Morris Goding
Access Consulting

127-129 Flowerdale Road,
Liverpool, NSW, 2170.

DA Stage Access Review

8 March 2019

Name	SGCH Flowerdale Road	Project Number	00012087
Project Address	127-129 Flowerdale Rd, Liverpool, NSW, 2170	Drawing Name	DDA Apartments
Client	SGCH	Scale	1:100@A3
		Date Commenced:	September 2018
		Drawing Number	DA509
		Revision	A

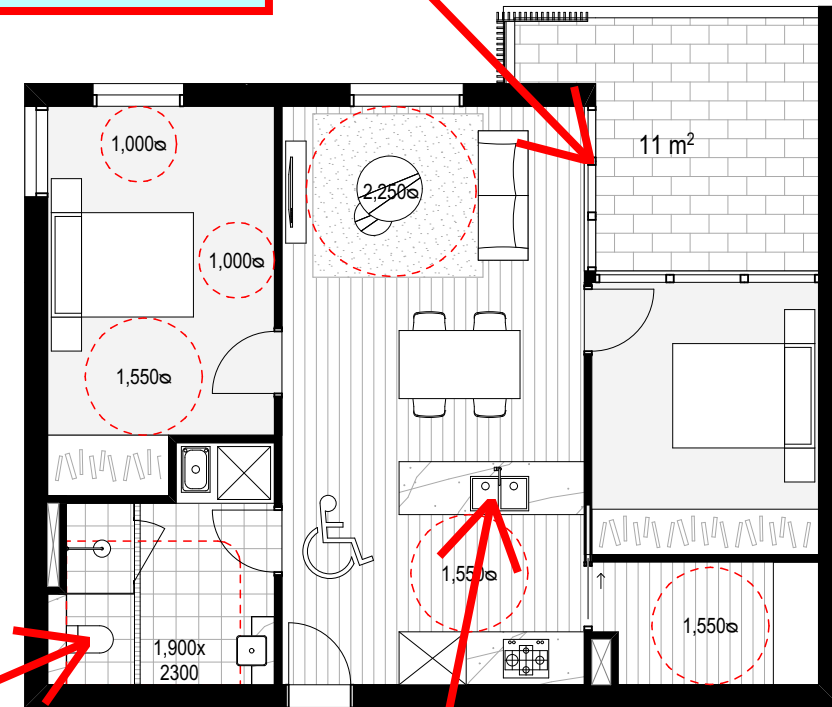
- All units have a bathroom layout with a left hand transfer WC pan. MGAC recommends revision of the base building plan to provide an even number of left-hand and right-hand transfer WC pans – refer mark-up on drawing DA509(A).
- The pre-post adaption for the kitchen relies upon moving of a kitchen bench containing a sink. This bench will need to be moved during the adaption phase. Ensure under the bench is fully tiled at the outset and plumbing penetrations are located such that they will be unaffected by the two locations of the bench before and after adaption – refer mark-up on drawing DA509(A).
- Ensure the external balconies have an accessible threshold from the internal living areas – refer mark-up on drawing DA509(A).

Ensure thresholds to doors in adaptable units to the external balcony are accessible

All 4 Adaptable units have right hand transfer pan arrangement. MGAC recommends consideration be given to providing 2 of units of each hand.

Ensure floor finish continues under kitchen bench and plumbing penetrations are located to suit the "before" and "after" location of the bench
